# PERMIT CHANGE TRACKING FORM

DATE RECEIVED	4/13/95	PERMIT NUMBER	ACT 1015/019
Title of Proposal:	Sewage System	PERMIT CHANGE #	95C
Description:	Connection to Trail Mtn. System & Cottonwood Mine	PERMITTEE	Pacificorp
		MINE NAME	Cottonwood Mine

**RE: TRAIL MOUNTAIN MINE SEWAGE SYSTEM MODIFICATION, PACIFICORP,  
COTTONWOOD MINE, ACT/015/019, EMERY COUNTY.**

**RE: TRAIL MOUNTAIN MINE SEWAGE SYSTEM MODIFICATION, PACIFICORP,  
COTTONWOOD MINE, ACT/015/019, EMERY COUNTY.**

**COTTONWOOD SURFACE  
SECTION OF DWG. WS449E  
MAP PACKET 3-16  
SCALE: 1"=50'**

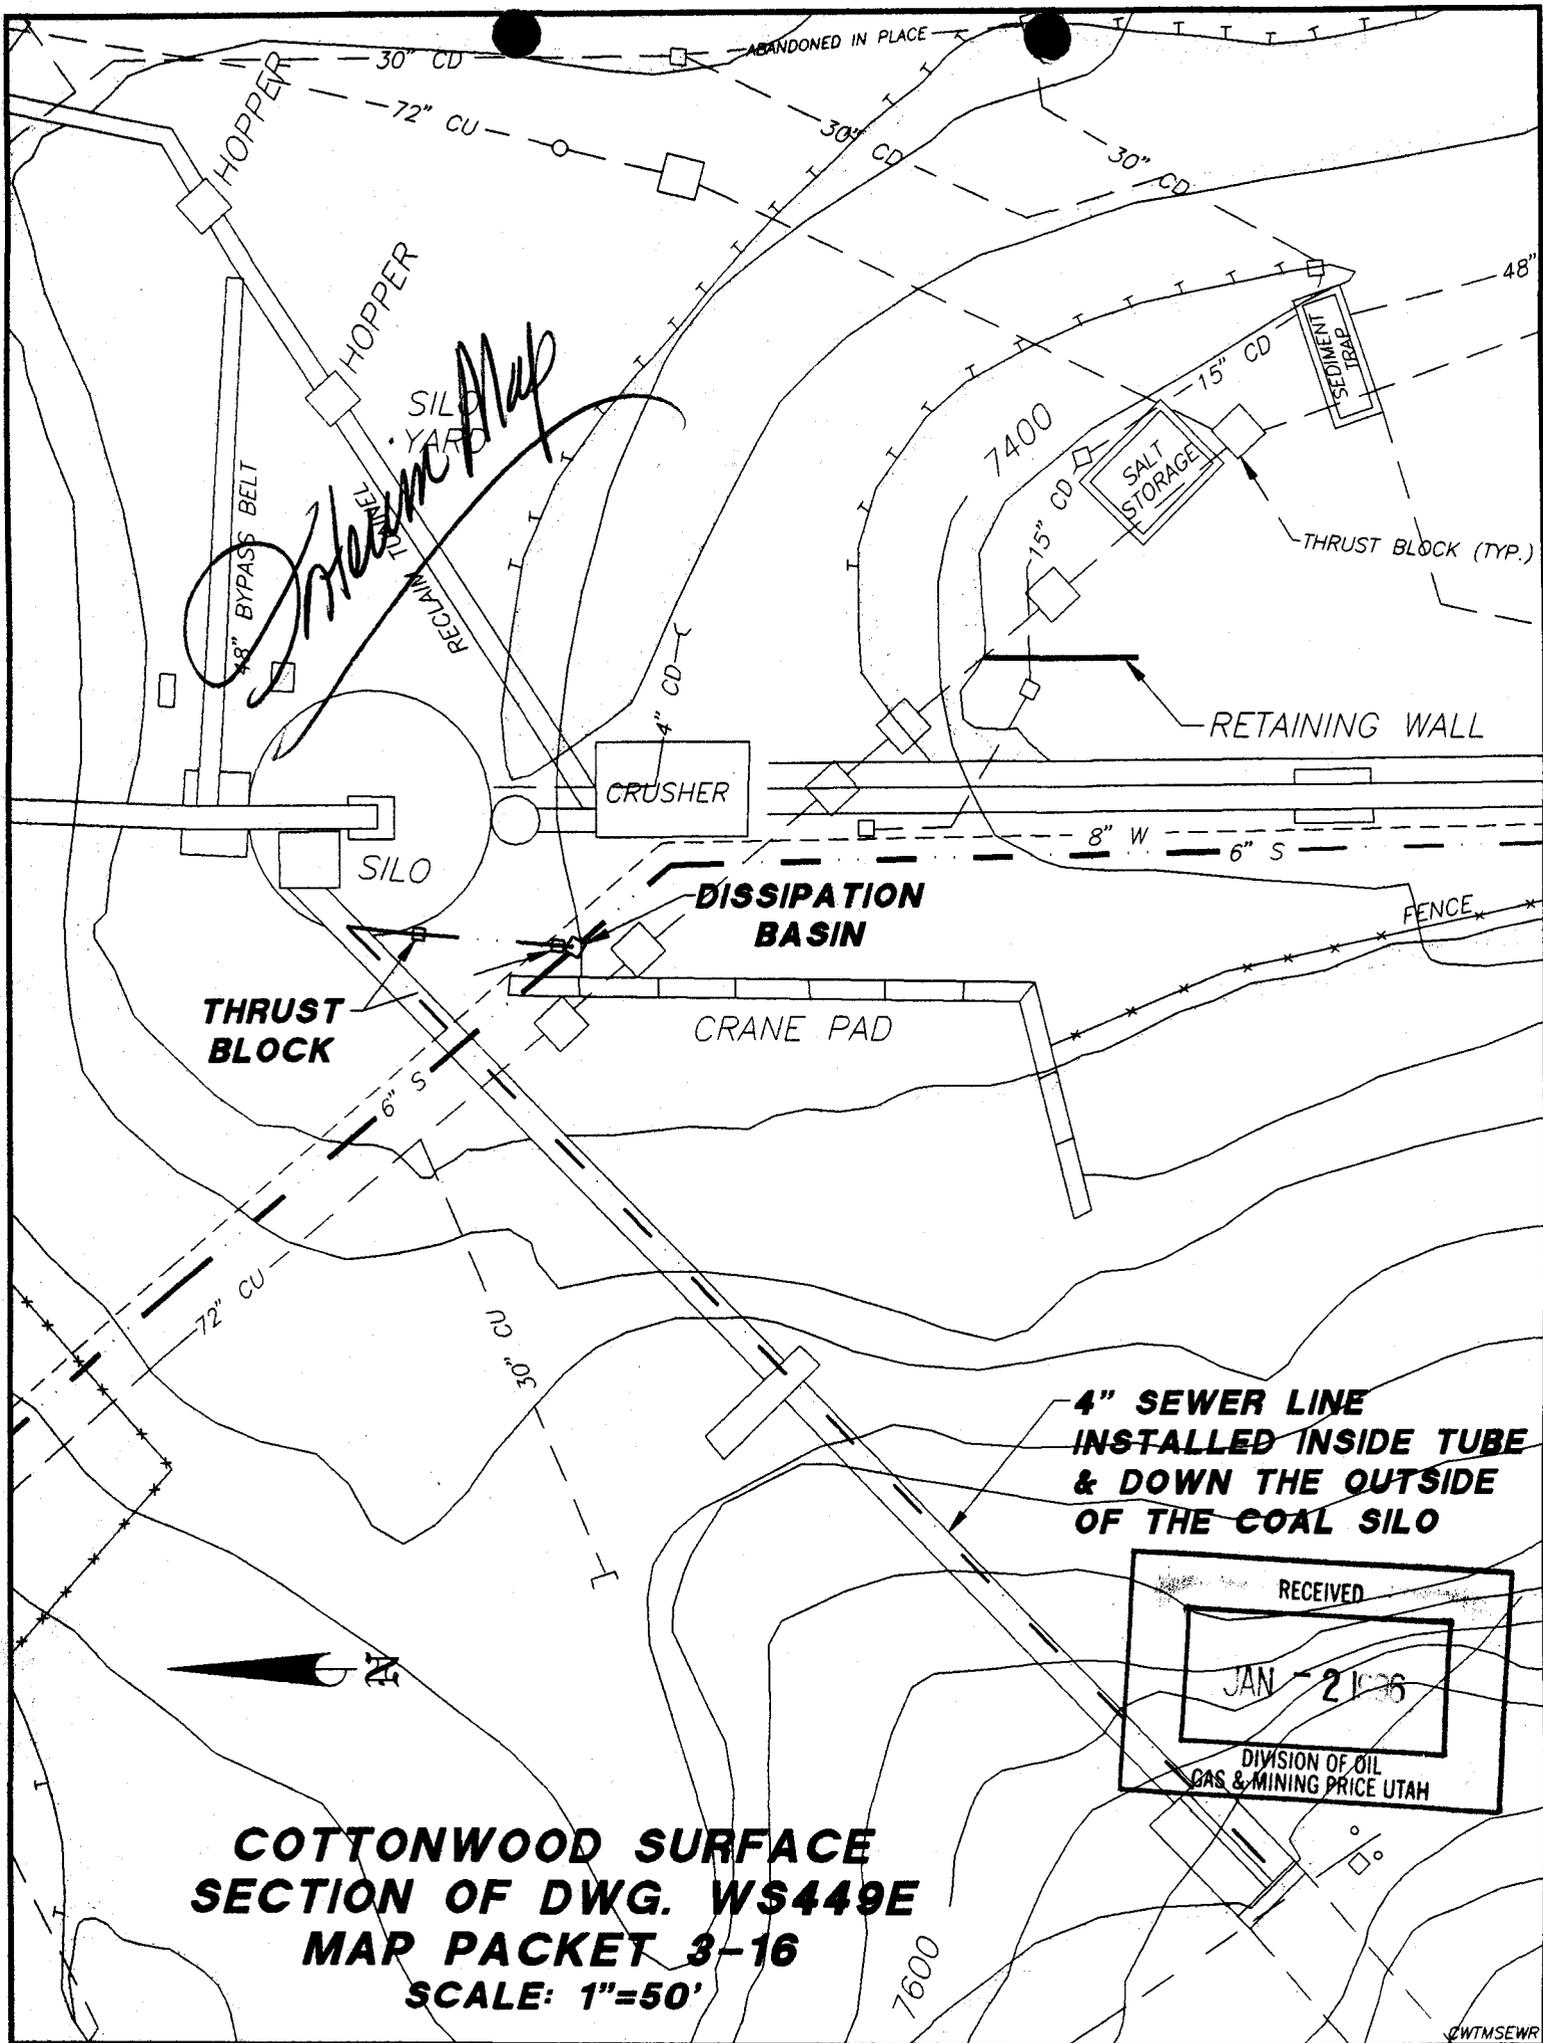
**4" SEWER LINE  
INSTALLED INSIDE TUBE  
& DOWN THE OUTSIDE  
OF THE COAL SILO**

**ENERGY DISSIPATION BASIN**

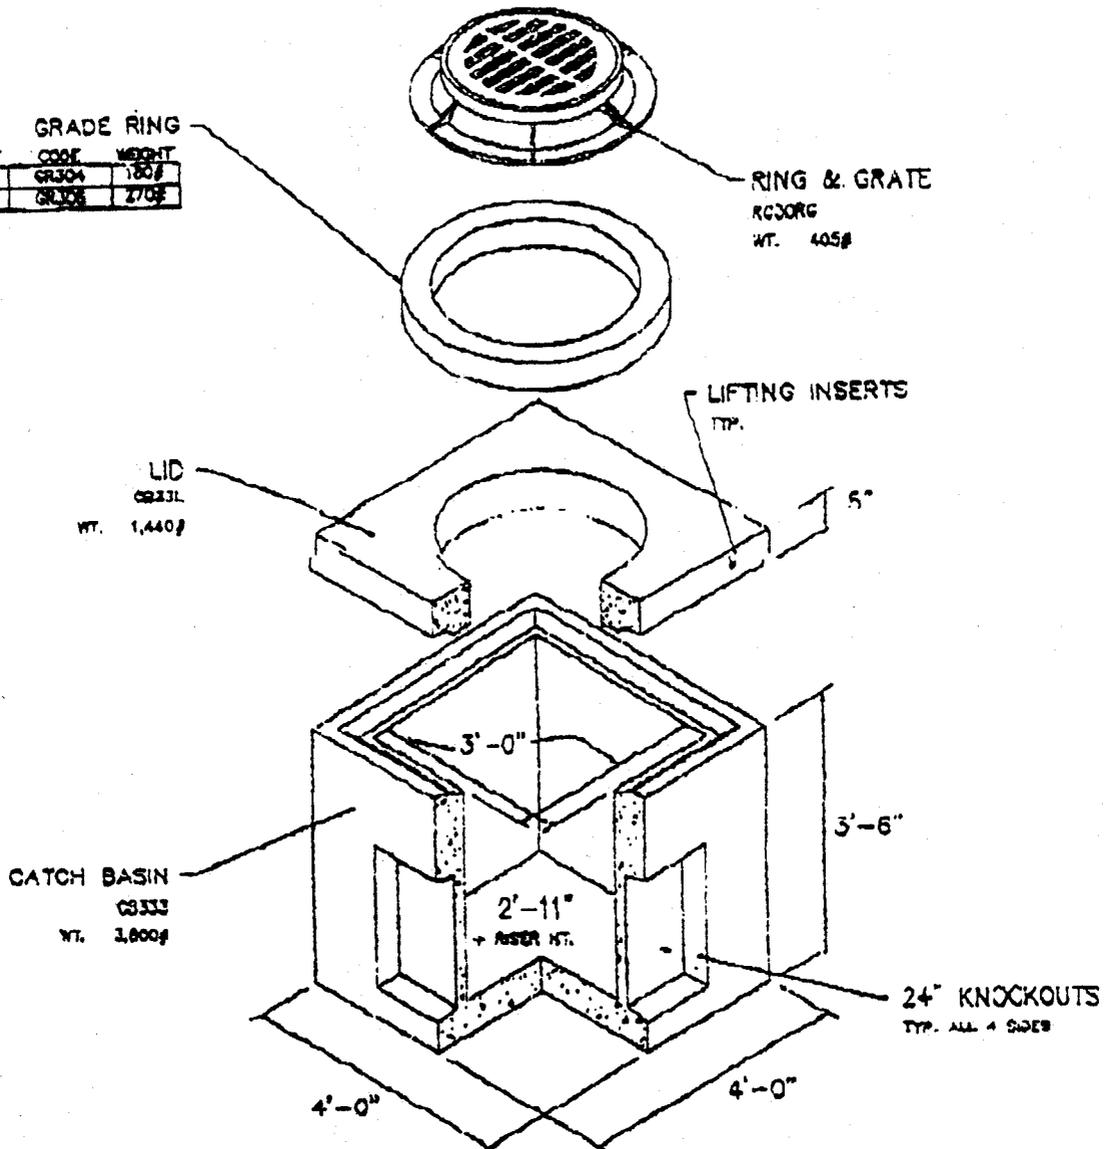
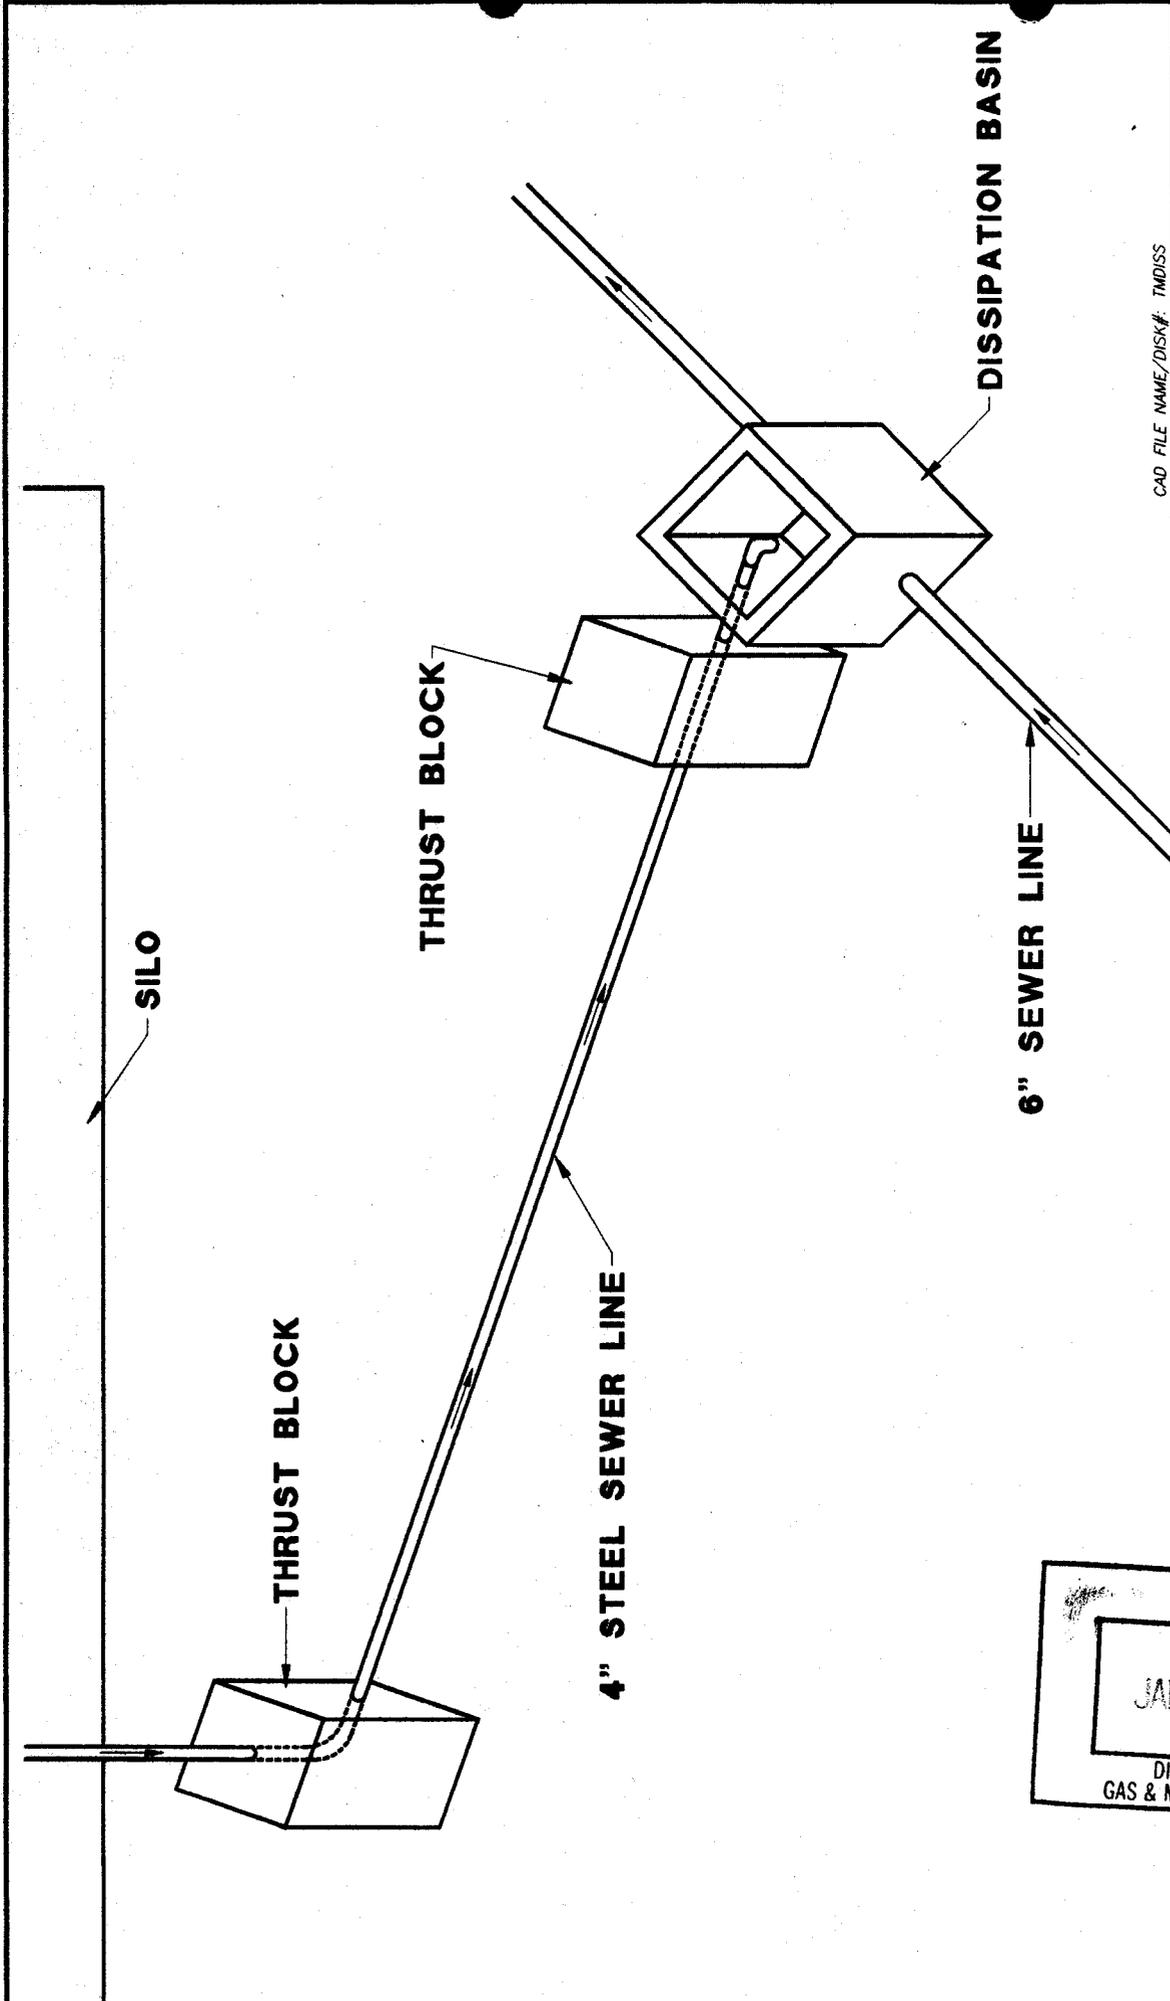
I received on November 20, 1995 proposed modifications to the approved plans for disposal of wastewater from Trail Mountain Mine. The proposed modifications comply with Utah Water Quality Rules (R317 UAC) and do not affect the design parameters approved in the construction permit dated March 17, 1995. I offer the following recommendation:

1. A small diameter hole should be provided in the energy dissipation weir to allow drainage upstream of the weir.

DRAWN BY:	K. LARSEN	FIGURE 1	
SCALE:	1" = 60'	DRAWING #:	
DATE:	MARCH 29, 1995	SHEET 1 OF 1	REV. _____

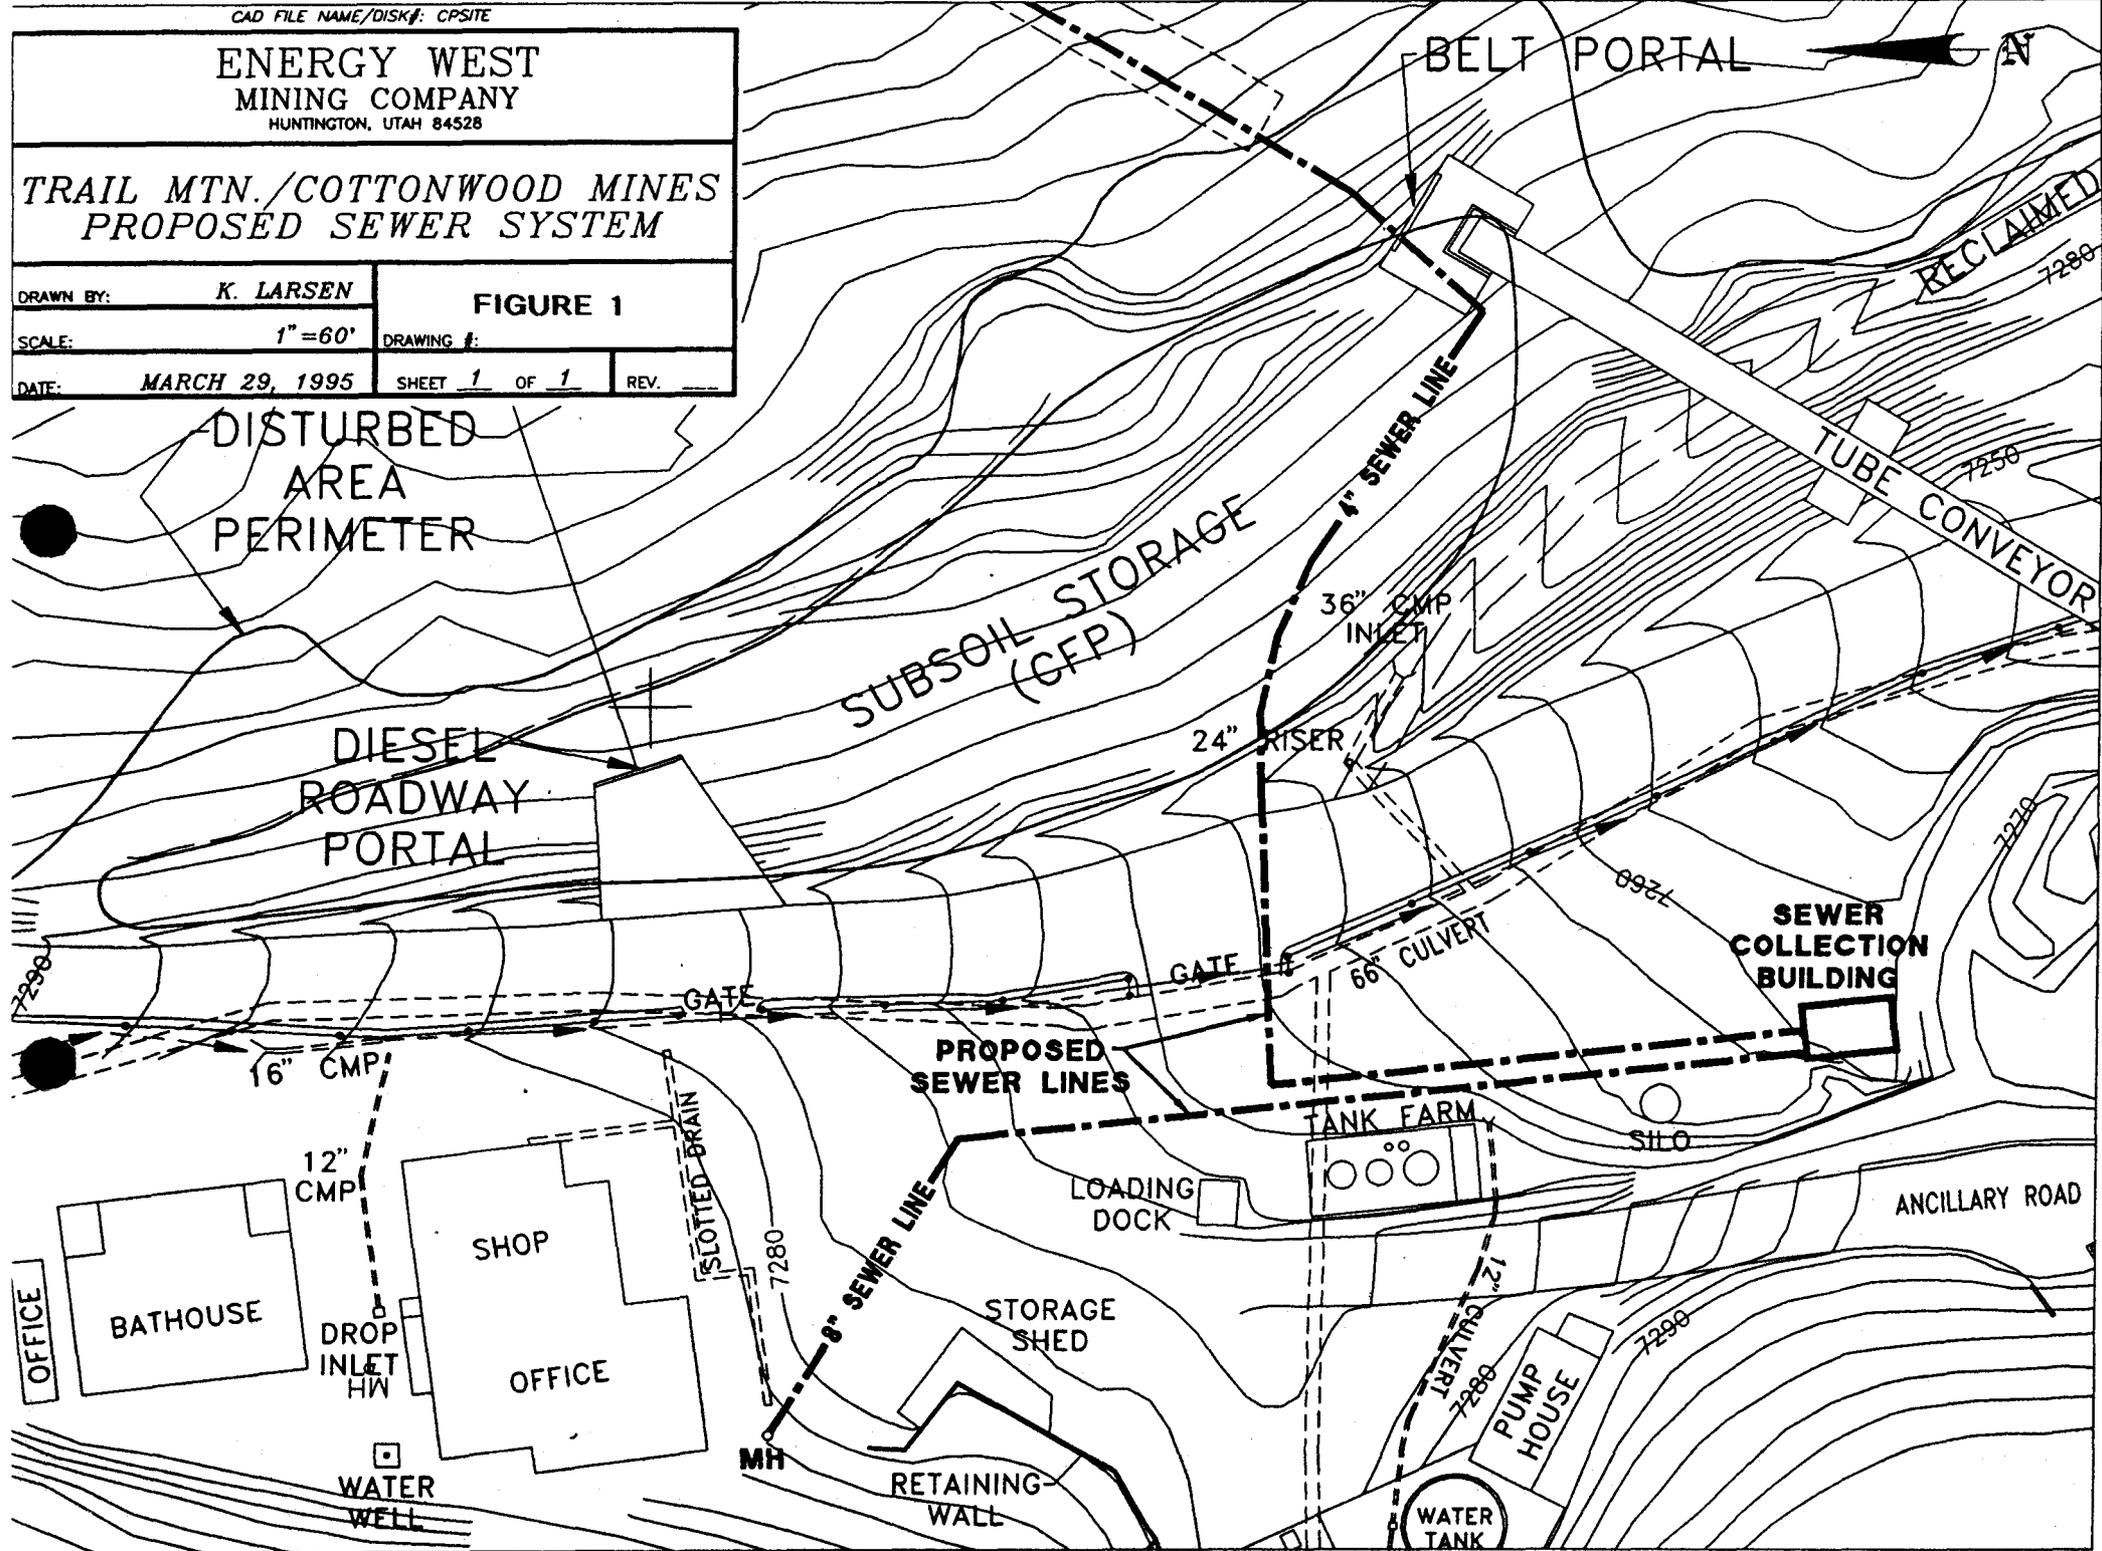
PacifiCorp requests that an amendment be granted to install a sewage line for the Trail Mountain Mine as described on pages 3-51 and 3-51.1, revised 3/29/95. The sewage system was approved by the Division of Water Quality on March 17, 1995 (See Attachment 1).

To help with the review of this amendment, Figures 1 through 3 have been included herein. Figures 1 and 3 depict the line location at the Cottonwood Canyon area and the Cottonwood Mine. Figure 2 is a typical cross-section of the buried line.
